WILDFLOWER SOCIETY OF WESTERN AUSTRALIA (Inc)

CPS 10607/1 Vasse-Yallingup Siding Road, Busselton

The Wildflower Society of WA (WSWA) recommends to the Department of Water and Environmental Regulation (DWER) that the Clearing Permit application CPS 10607/1 submitted by the City of Busselton for clearing of native vegetation, including 26 trees, to allow road widening along Vasse-Yallingup Siding Road reserve, Marybrook, not be approved.

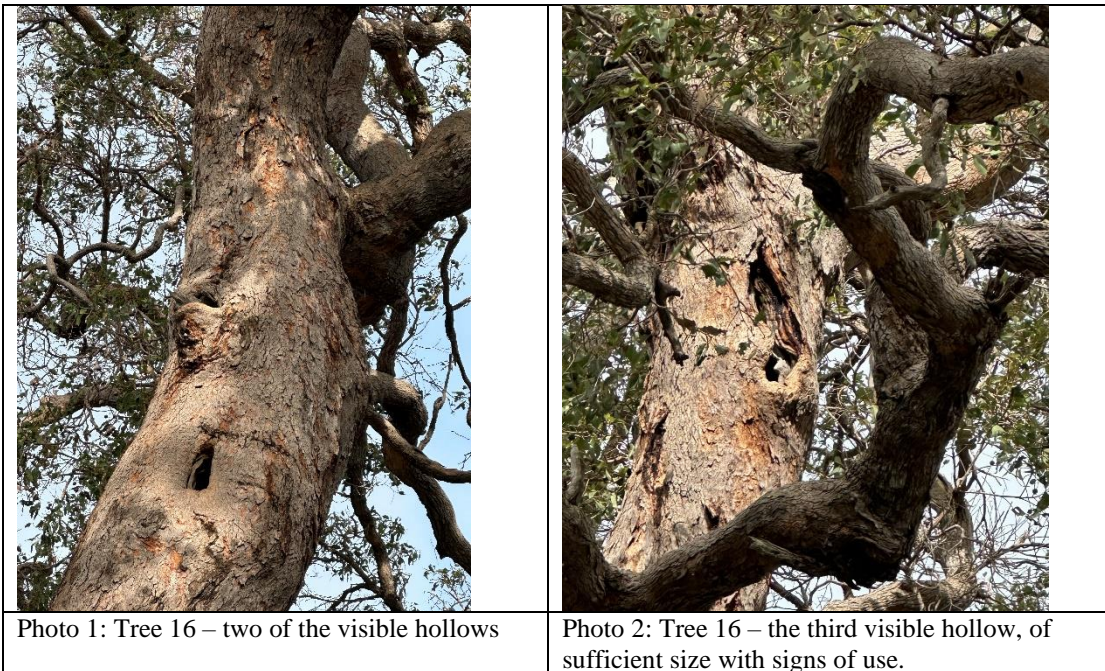
With respect to Baudin's Cockatoo (Endangered), Carnaby's Cockatoo (Endangered) and Forest Red-tailed Black-cockatoo (Vulnerable) that occur within this area, fifteen of the 26 trees proposed to be cleared are *Corymbia calophylla* or *Eucalyptus marginata* subsp. *marginata* with a DBH more than 50cm. There are potential nesting trees for these three species with two trees identified as having small hollows. These trees also provide suitable roosting and foraging habitat for Black Cockatoos. A rapid assessment of these trees shows that Tree 16 includes a number of hollows that require further investigation, photos below.

- Further investigation for retention of the larger trees, in particular Tree 16 which has a hollow suitable for Black Cockatoos, with signs of use. (Photo 1 and 2). This tree appears to have a DBH greater than 100cm, has numerous hollows, is located within a cleared driveway area and appears to pose little risk to road users who are travelling to the posted speed limit. One hollow appears to be of sufficient size to allow entrance by Black Cockatoos, with signs of use. There is increasing evidence that the required entrance size to hollows for Black Cockatoos can be as small as 10cm, with the size of the interior hollow the more limiting factor for breeding use. The photos of the other hollows on this tree show it clearly has significant hollow space within the trunk. This application should be referred under the EPBC Act to ensure that a Black Cockatoo breeding tree is not removed without alternative options being sought or, as a worst-case scenario, the required approvals being granted. Further investigation of the remainder of the trees, in particular Tree 12 which we have not had the

- Federal referral under the EPBC Act for the proposed clearing of Tree 16.

Figure 1 Crash incidence 2013 to 2023.

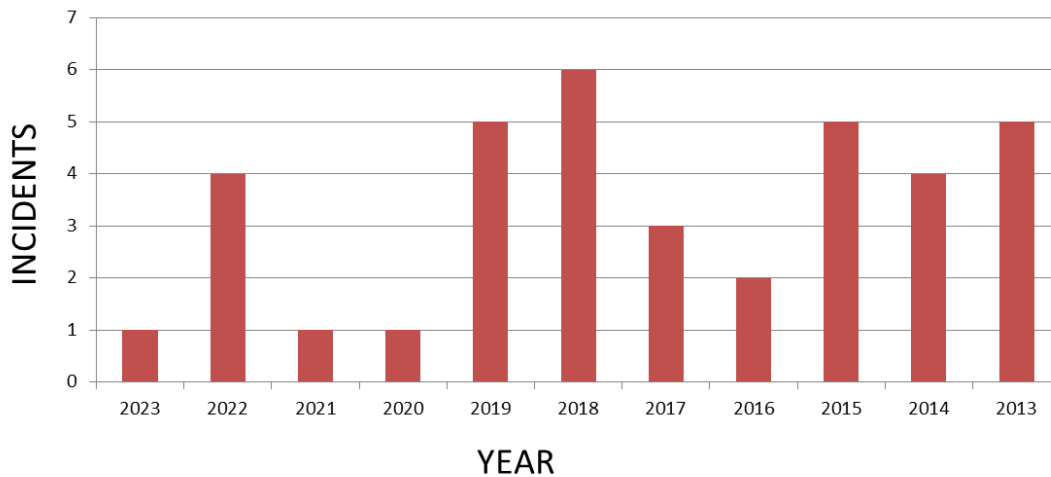
Crash incidences per year revealed a trend toward decreased incidence over time, decreasing overall in the period 2013-2023, confirming the reducing incident rate over time (see Figure 1).

Of note, from 2019 onwards, when further speed restrictions were implemented, the data showed a reduced incidence maintained over the 4 years since. These data indicate that a further speed reduction may further reduce risk of uncontrolled tarmac departures (see Figure 1 and incident Trend Figure 2).

Figure 2 Crash Incidence Trend

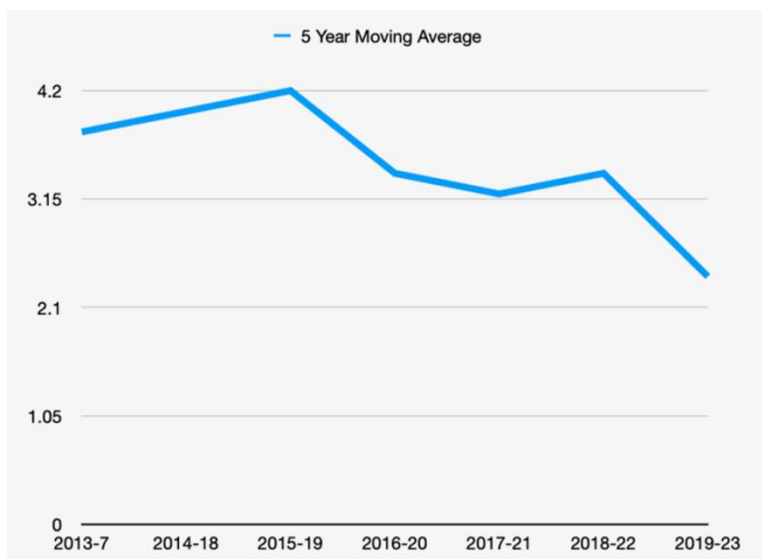
Figure 2 provides a clear view of improving safety of the road overall, associated with speed reduction actions in 2019. Serious consideration should be given to localised speed restriction along the proposed tree removal area, with a minimum of 6 months active policing to encourage compliance.

Figure 3

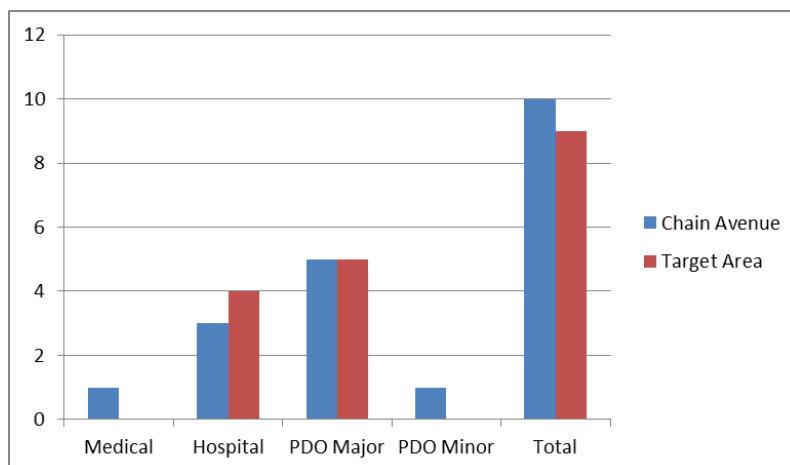
- The safety of the road has been improving and a reasonable inference would be the reduction in speed limits on the road in 2019 has materially contributed to the reduced incidence of events. A further management of speed, particularly in potential hot spot areas, would appear to be a non-invasive and effective strategy.
- The risks associated with the Chain Avenue intersection should be noted and roundabouts or realignment should be a higher priority than removal of trees and concomitant flora and fauna disturbance (see Figure 3).

Chain Avenue Intersection and Targeted Tree Clearing Zone

The solution is not removing the trees, but to make the speed zoning commensurate with the road environment, and to rigorously enforce the appropriate posted speed limit. This should be supported by road signage cautioning drivers to slow down, and advising that trees are close to the edge of the road. This is what DBCA and Shire of Wanneroo have done on the approach road to Yanche National Park to avoid the need to remove historic and aesthetically important trees. The
